TRANS/WP.29/GRSG/60
21 December 2001

Working Party on General Safety Provisions (GRSG)

REPORT OF THE WORKING PARTY ON GENERAL SAFETY PROVISIONS (GRSG)
ON ITS EIGHTY-FIRST SESSION

(8 to 11 October 2001)

Model A

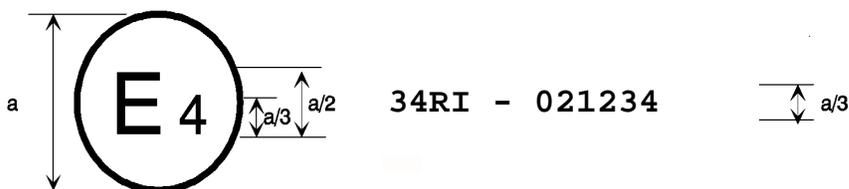
Annex 2, amend to read:

a = 8 mm min

The above approval mark affixed to a vehicle shows that the type concerned was approved in the Netherlands (E4) pursuant to Part I of Regulation No. 34 under approval No. 021234. The first two digits (02) of the approval number indicate that the approval was granted in accordance with the requirements of Regulation No. 34 as amended by the 02 series of amendments.
